11869A RF PLUG-IN ADAPTER

MANUAL PART NO. 11869-90006
Microfiche Part No. 11869-90007

SECTION VII
MANUAL BACKDATING CHANGES

Figure 7-1. 11869A RF Plug-In Adapter (CHANGE A)

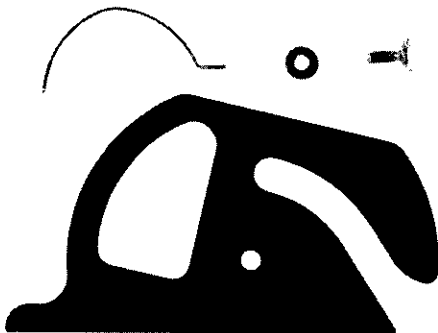
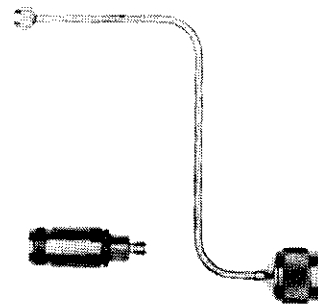
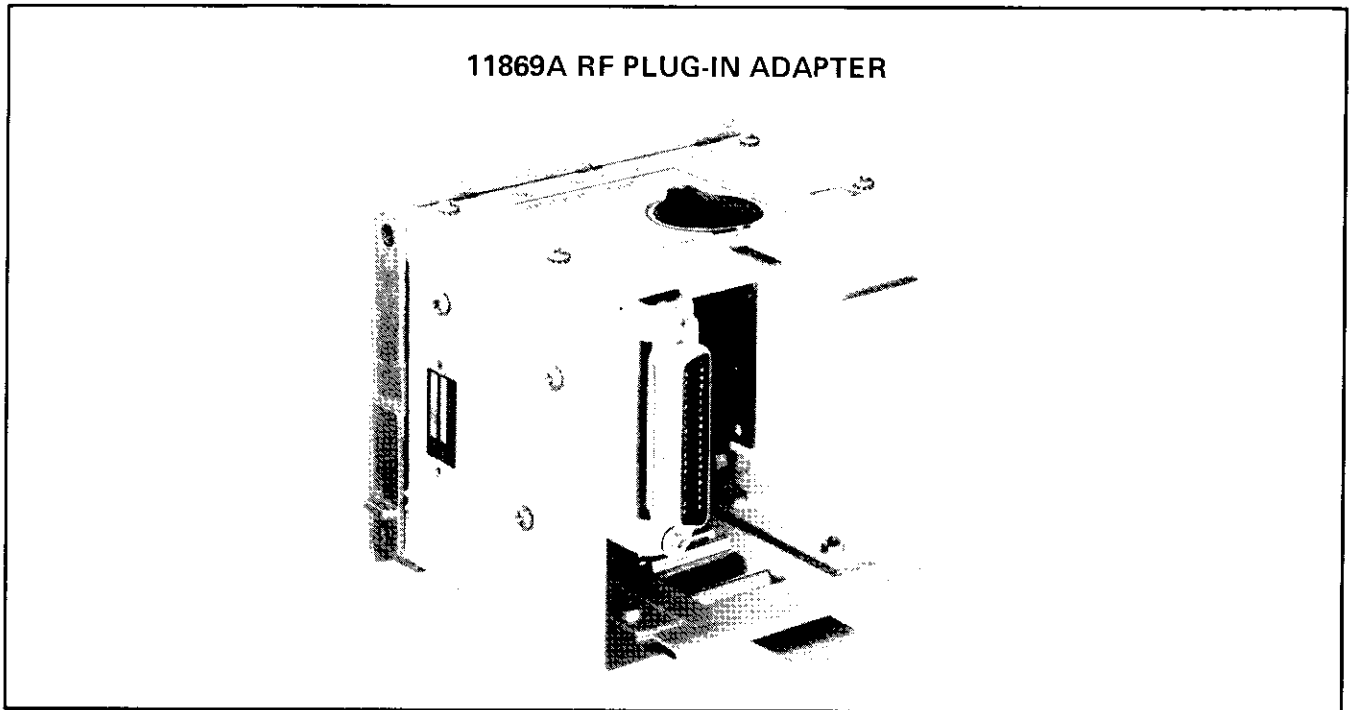
Page 1-0, Figure 1-1:

Replace the photograph of the 11869A RF Plug-In Adapter with the **11869A RF Plug-In Adapter (CHANGE A)** photograph in this section.

Delete the **OPTION 006 AUX OUT CONNECTOR AND CABLE** photograph.
Delete the words 'Factory Installed' adjacent to the FM INPUT cable.

Figure 7-2. Mechanical Parts (1 of 2) (CHANGE A)

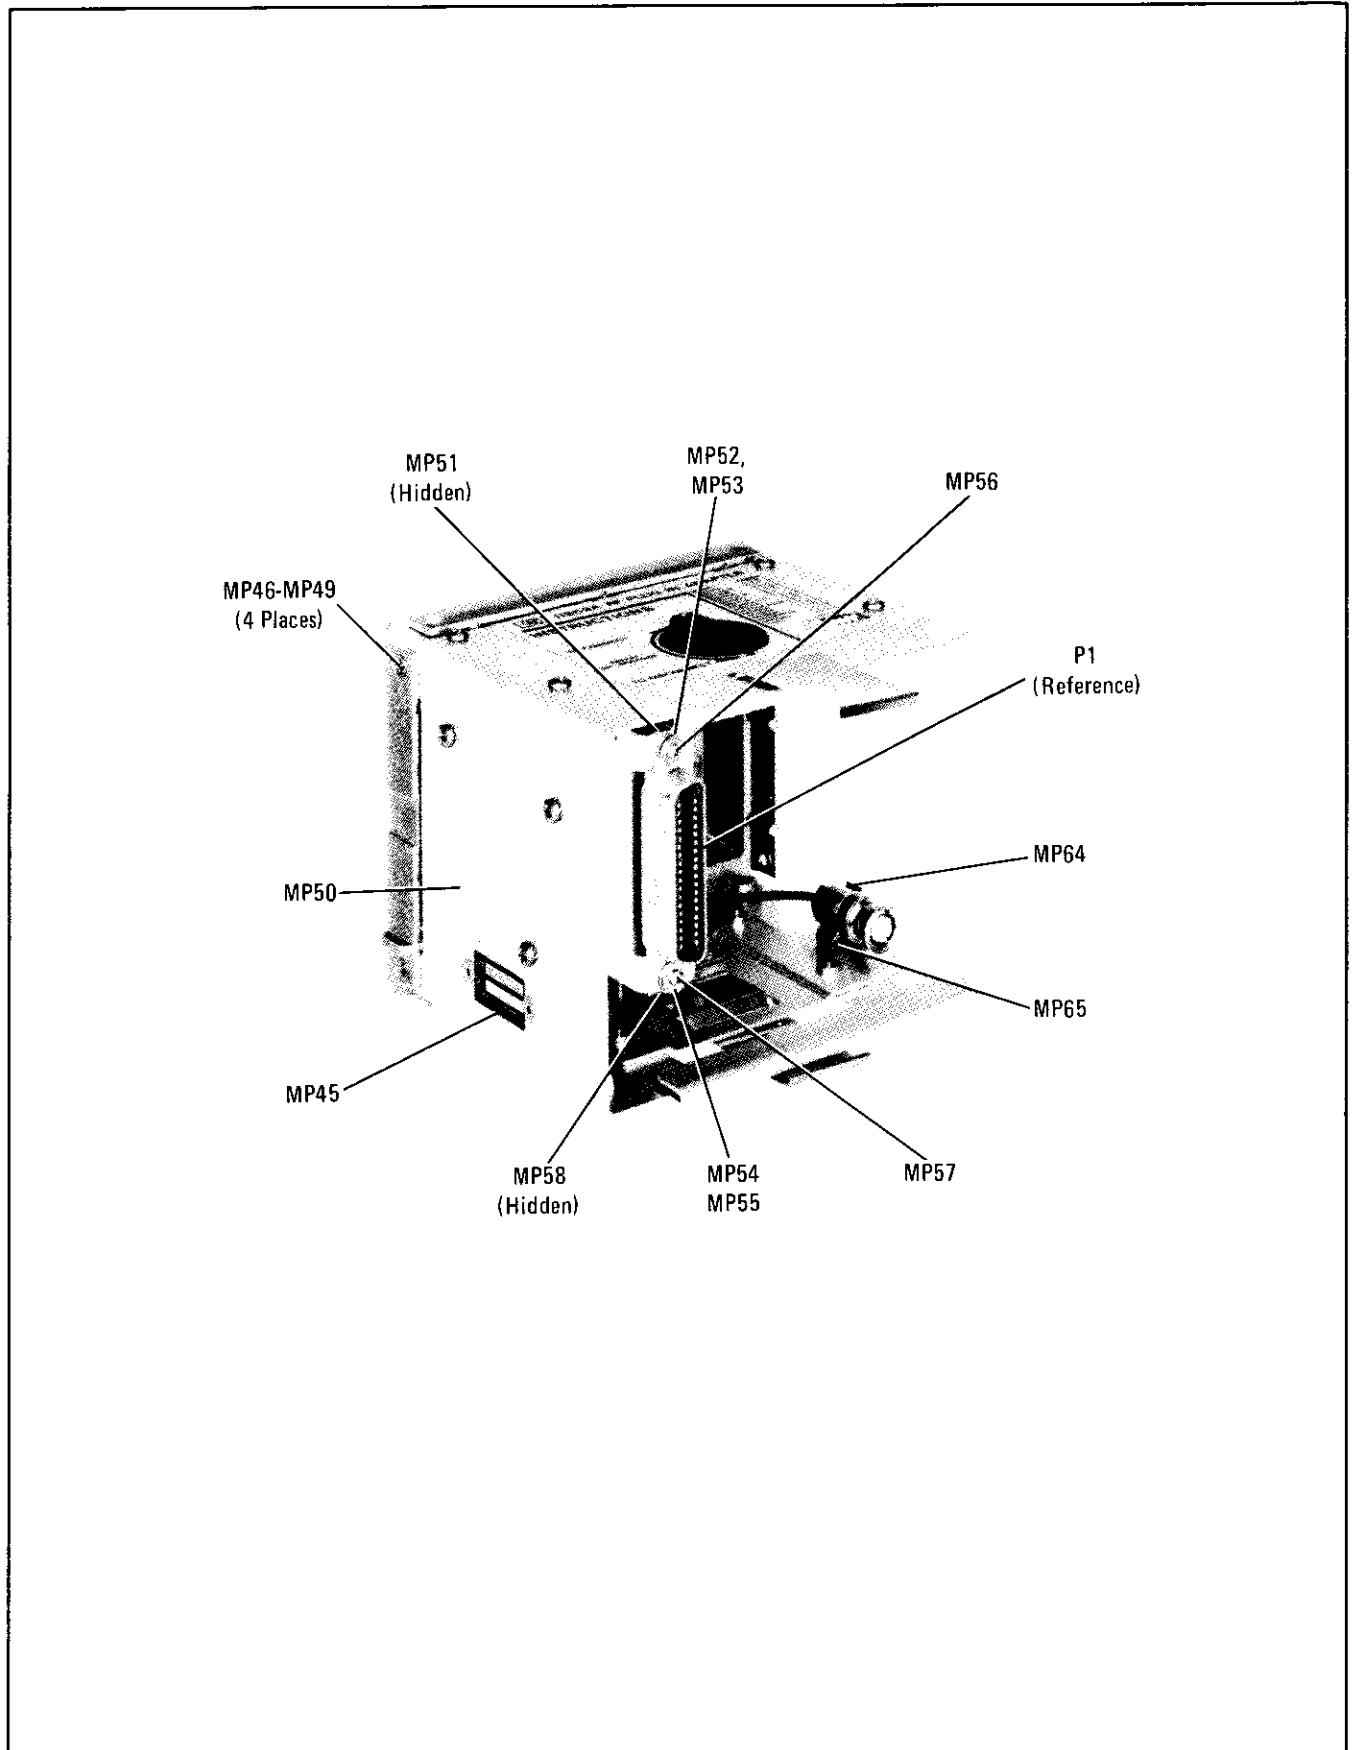
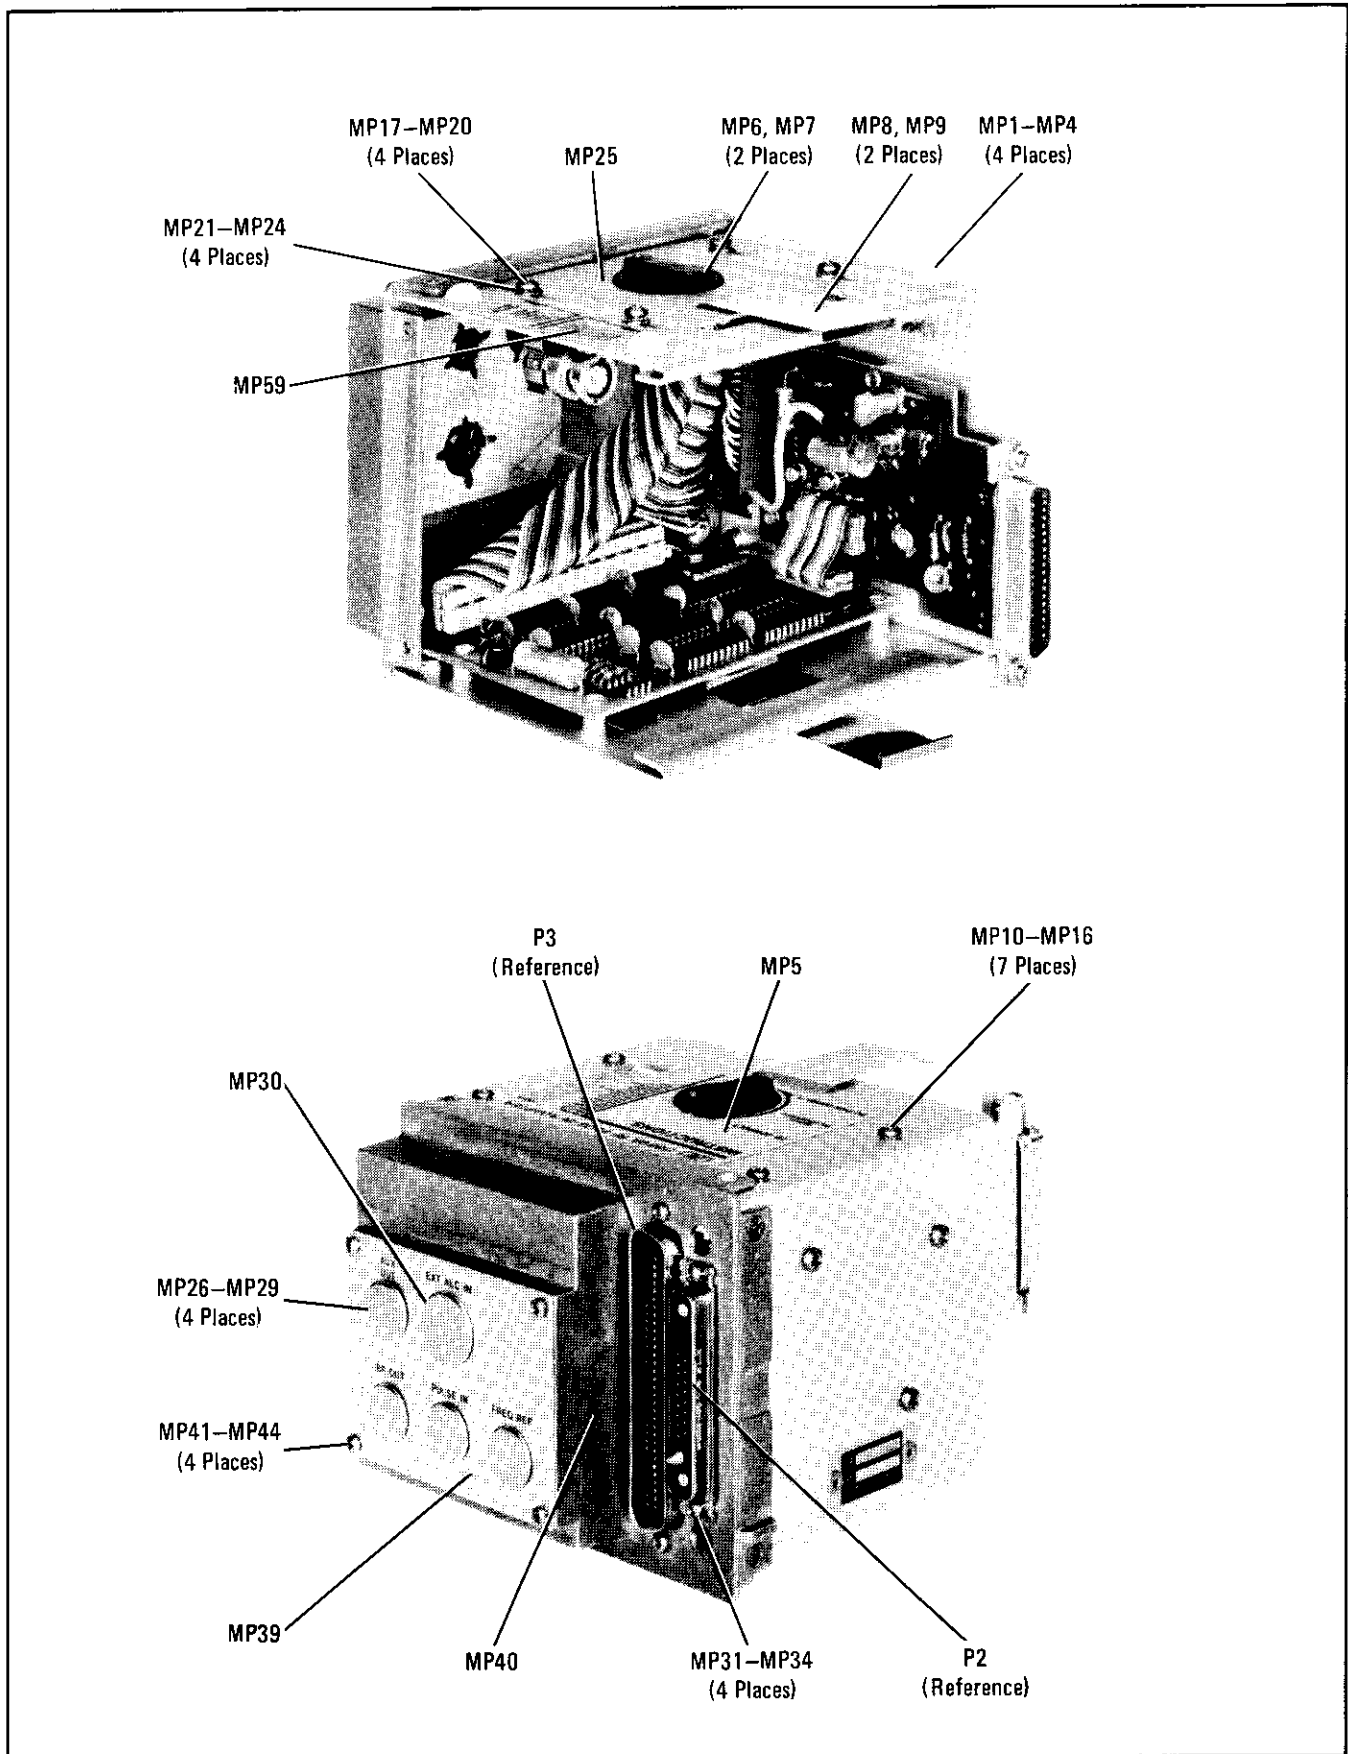
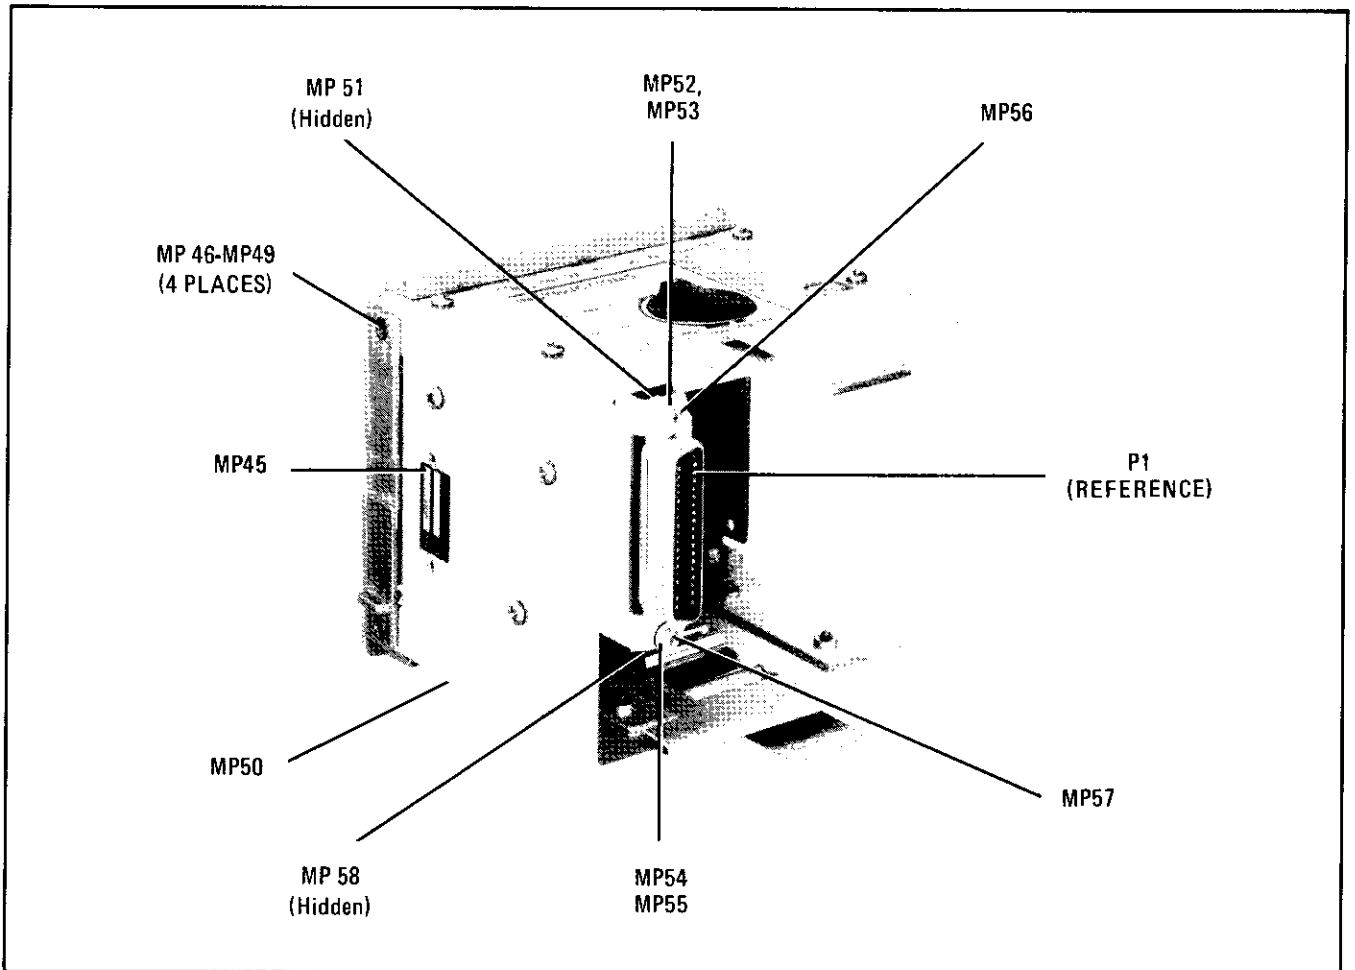
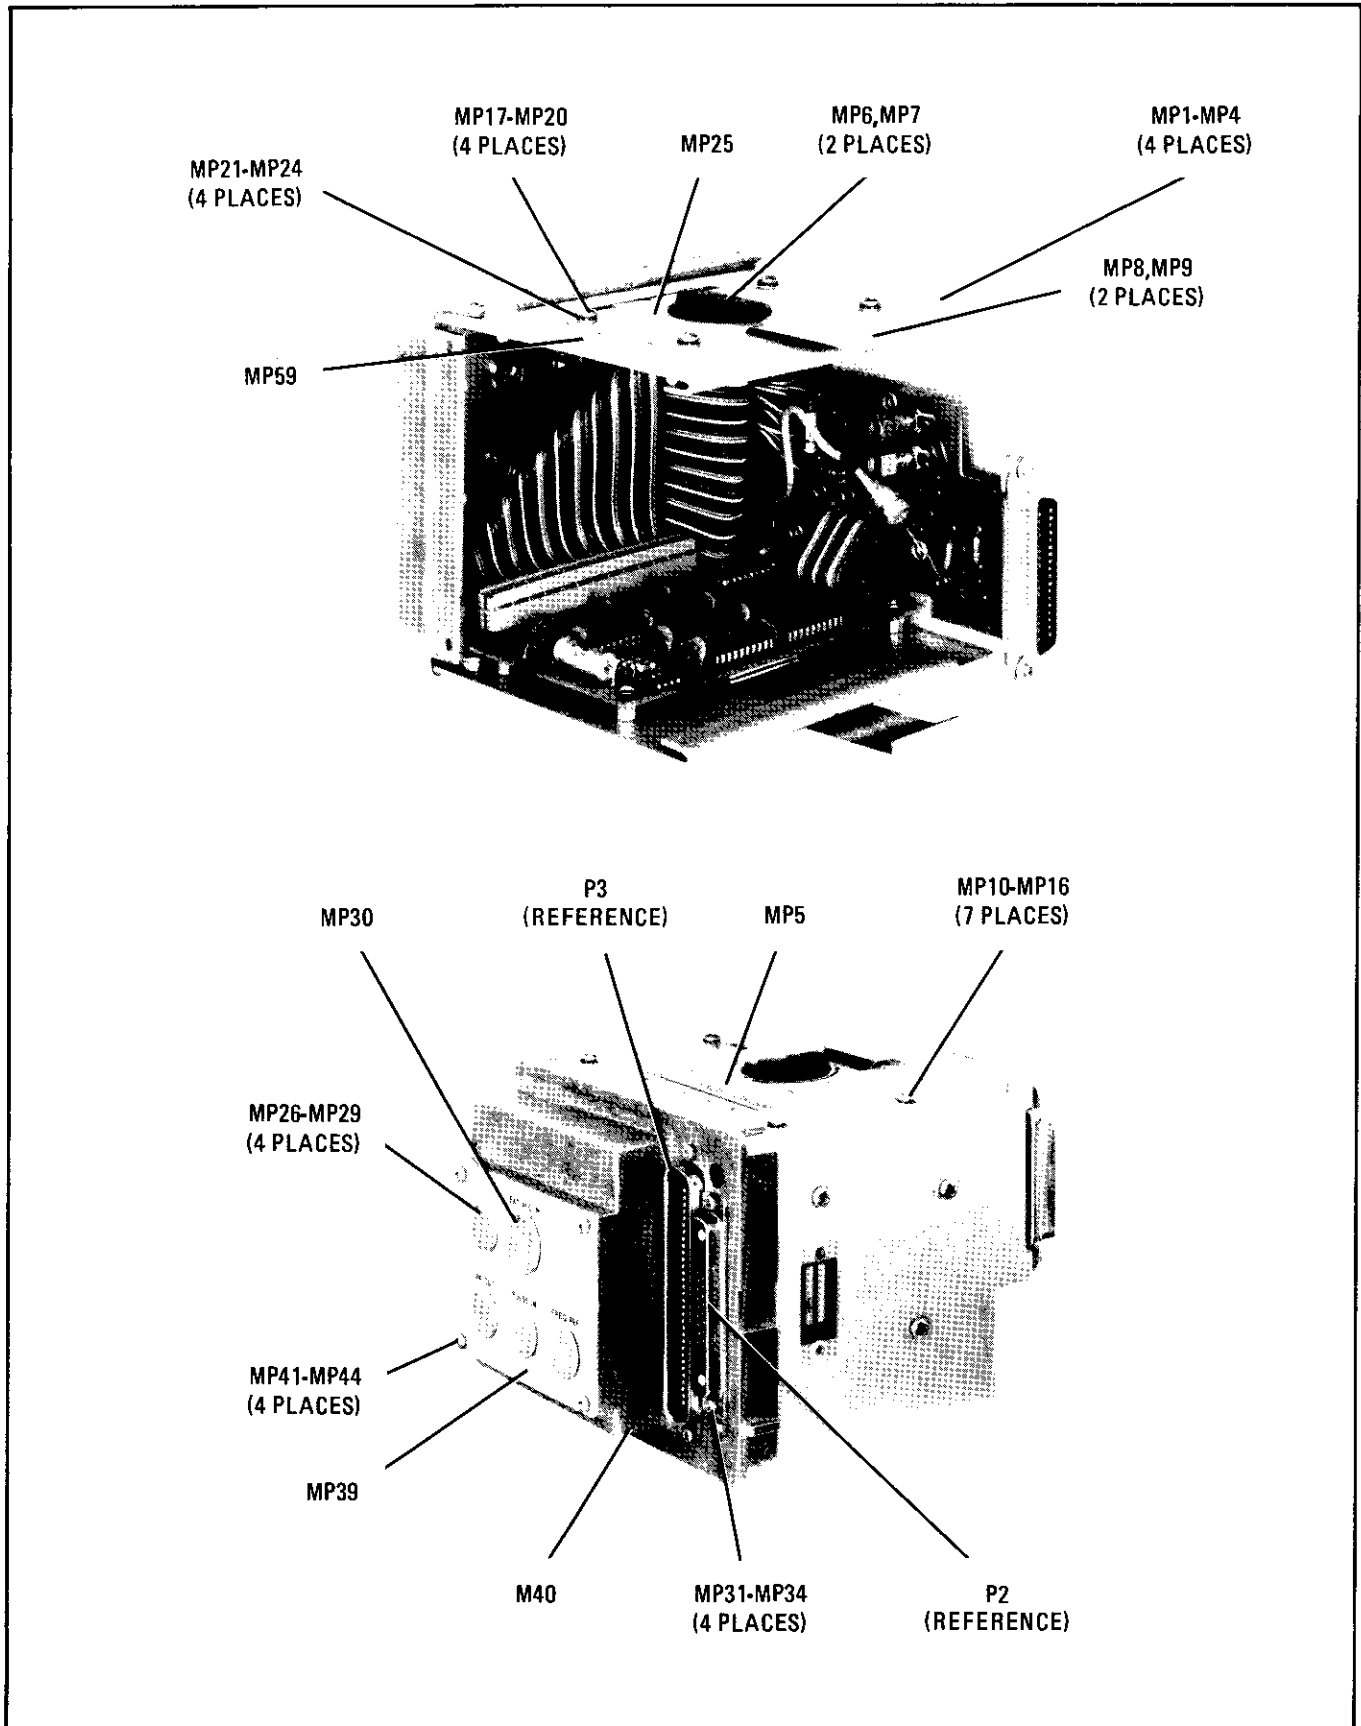
Page 6-8, Figure 6-1:
Replace Figure 6-1 with **Mechanical Parts (1 of 2) (CHANGE A)** and **Mechanical Parts (2 of 2) (CHANGE A)** in this section.
